FROM: AMHI Center Building Storage Addendum 1

RE: Addendum No. **1 (One)** to the Bidding Documents

AEI Project Name: AMHI Center Building Museum Storage

ADDENDUM 01 - 10.21.2021

SHEET 1 OF 1

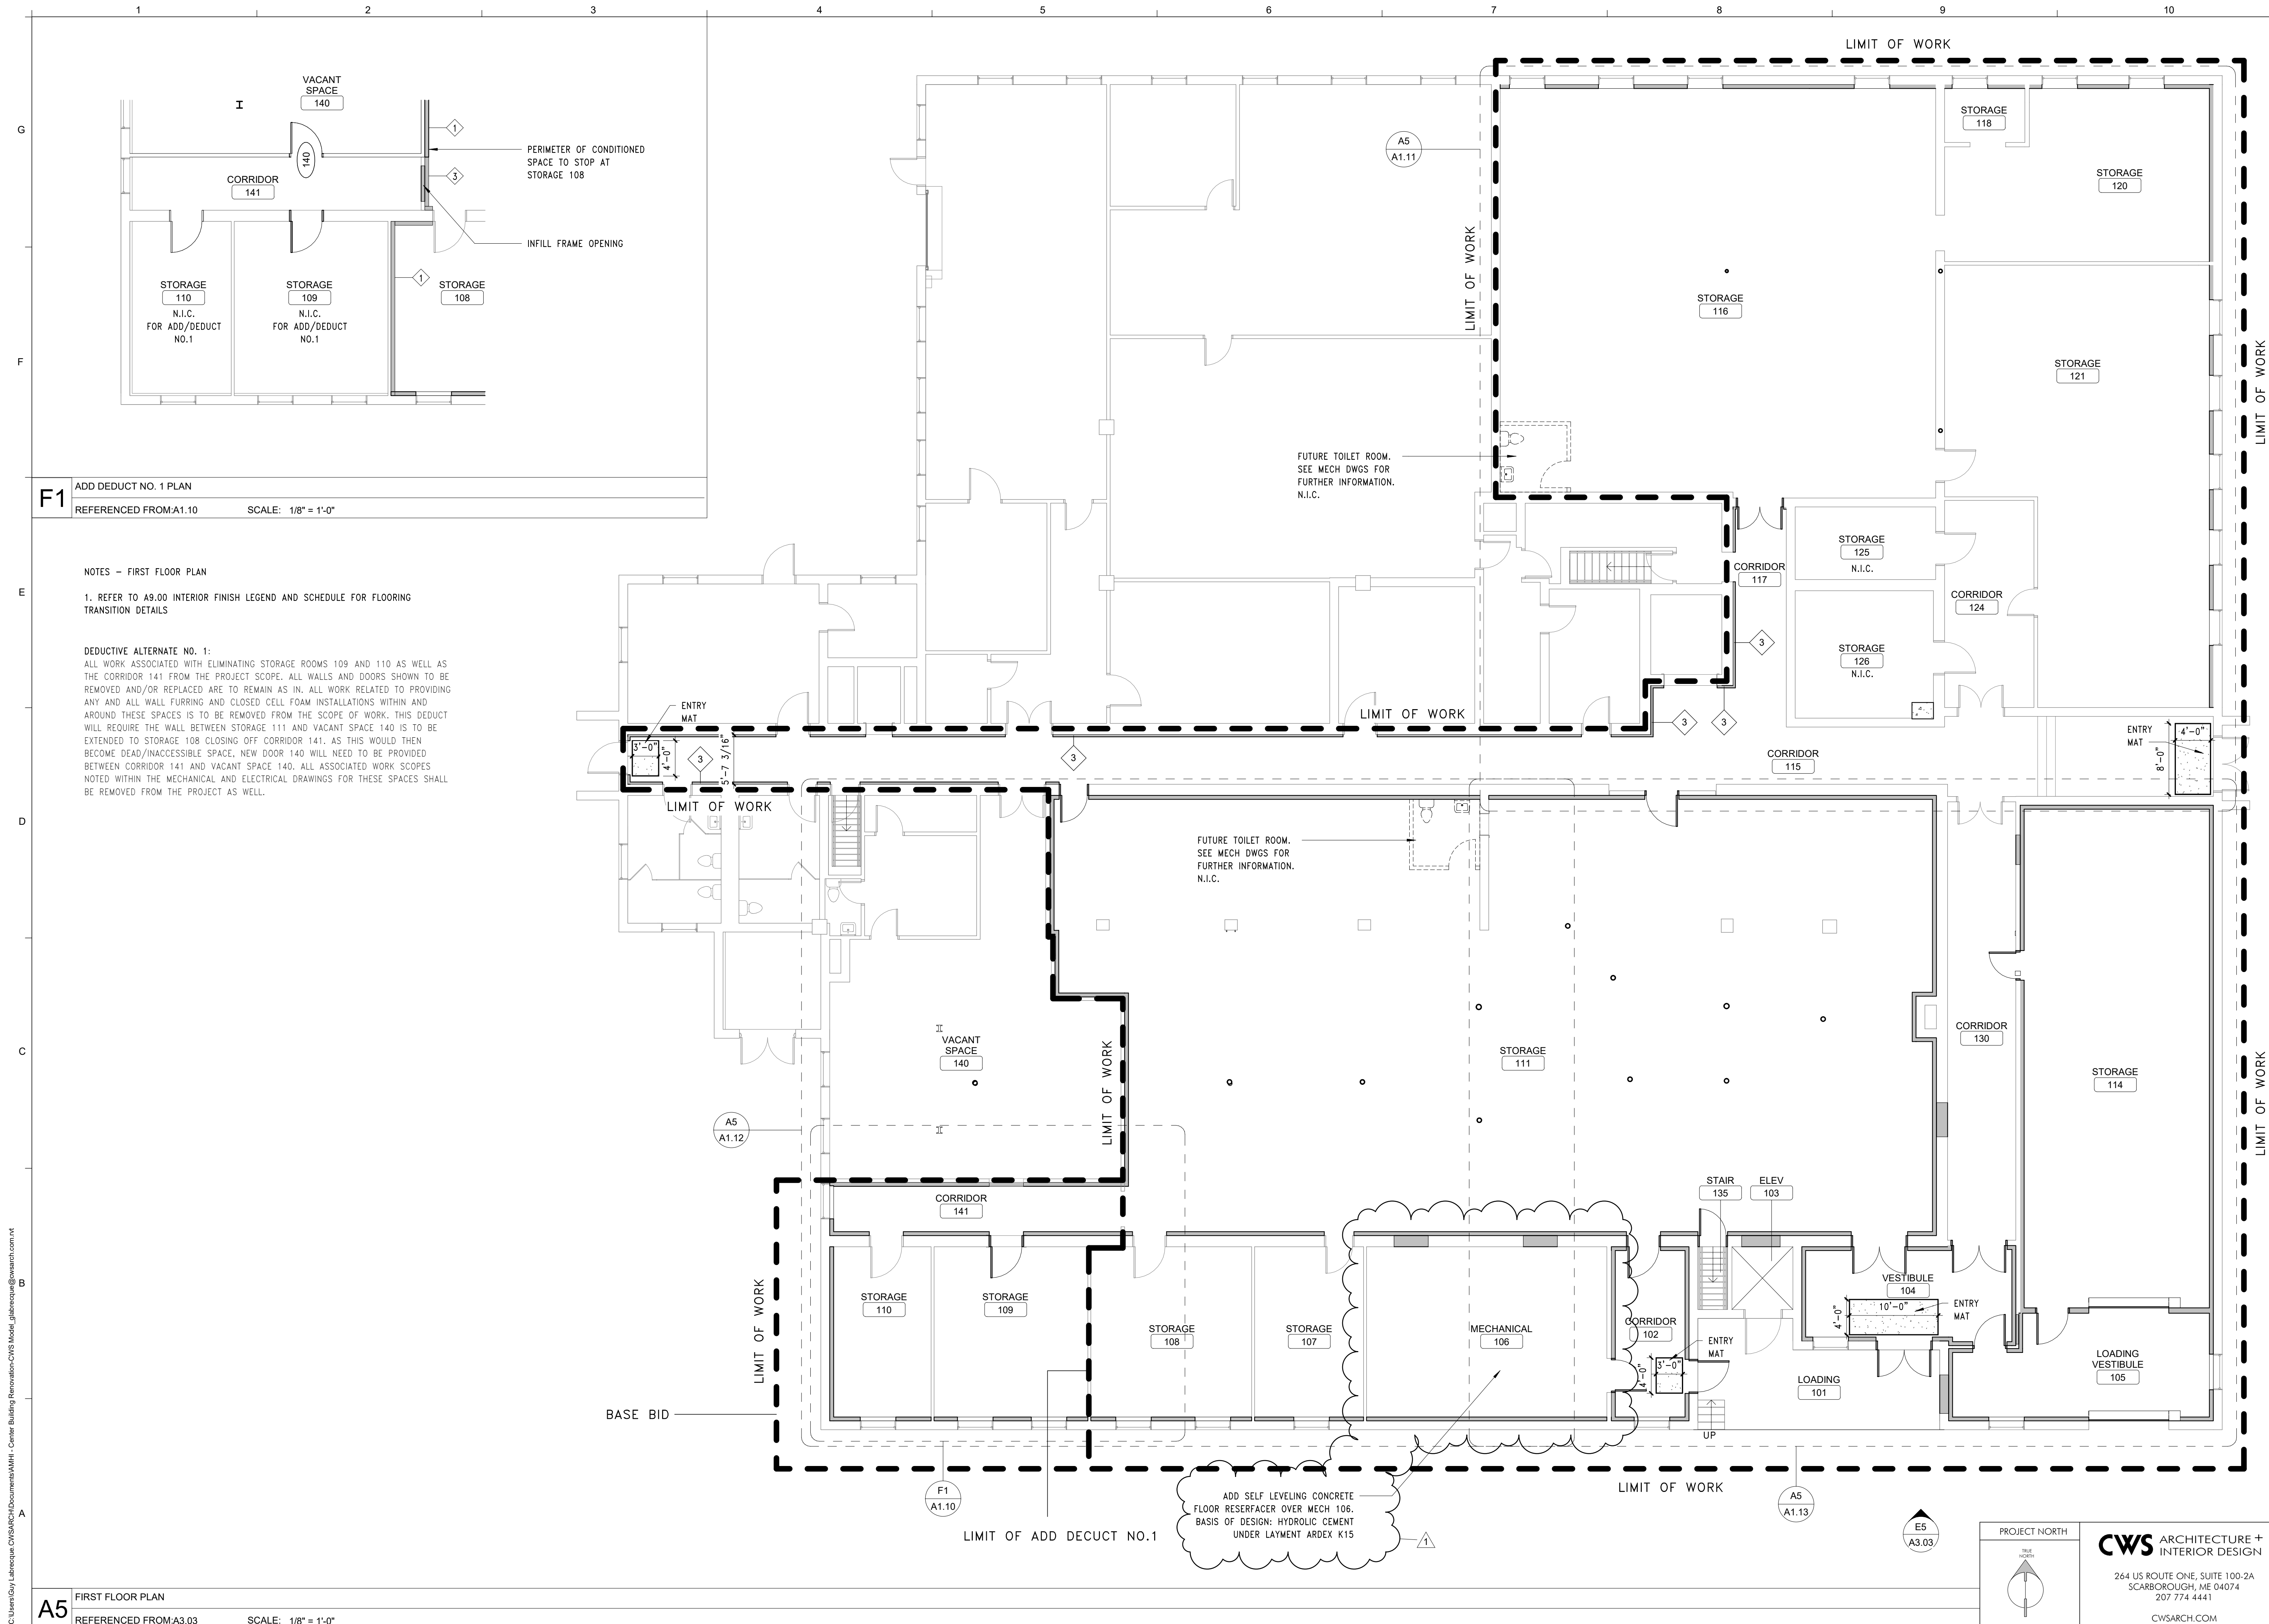
1. **SHEET 1 of 1 – WATER SERVICE PLAN – CENTRAL BUILDING**
 - a. Water line service
2. **SHEET A1.10 – OVERALL FIRST FLOOR PLAN**
 - a. Changes to Mechanical Room #106
3. **SHEET AD1.12 – ENLARGED REMOVALS PLAN – SOUTH**
 - a. Changes to Mechanical Room #106
4. **SHEET AD1.13 – ENLARGED REMOVALS PLAN – SOUTH**
 - a. Changes to Mechanical Room #106
5. **SHEET SF-101 – STRUCTURAL – ROOF FRAMING PLAN**
 - a. Changes to Mechanical Room #106
6. **SHEET EL-110 – FIRST FLOOR LIGHTING PLAN**
 - a. Changes to Mechanical Room #106
7. **SHEET EY-110 – FIRST FLOOR SYSTEMS PLAN**
 - a. Changes to Mechanical Room #106
